MANUFACTURING DRAWING

IDENTIFICATION (EMBOSSING + MARKING)

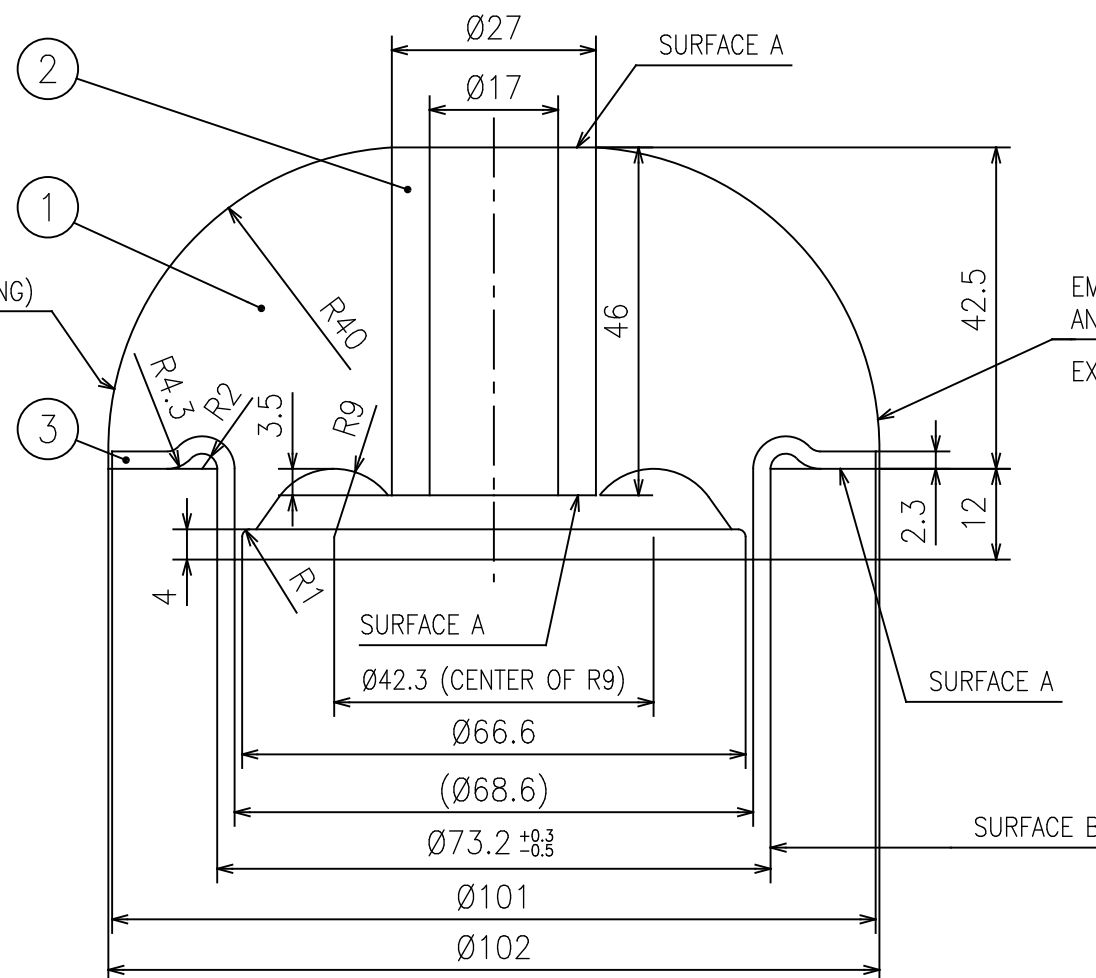
1 ~~42161~~
EMBOSSING: V1411-42162

1. THIS PART DIFFERS FROM V1411-4215A IN STATIC SPRING RATE AND RUBBER SHAPE.
2. THIS PART DIFFERS FROM V1411-42151 AND V1411-4219A IN RUBBER HARDNESS.
-  ~~3. THIS PART DIFFERS FROM V1411-42161 IN IDENTIFICATION MARKING.~~
4. SURFACE A (ENTIRE SURFACE) IS A FASTENING SURFACE (SEE INSTALLATION DRAWING); NO RUBBER FLASH IS PERMITTED.
MARKING RUNS ON SURFACE A (ENTIRE SURFACE) ARE ACCEPTABLE.
NO LOOSE RUBBER FLASH IS PERMITTED ON SURFACE B (ENTIRE CIRCUMFERENCE).
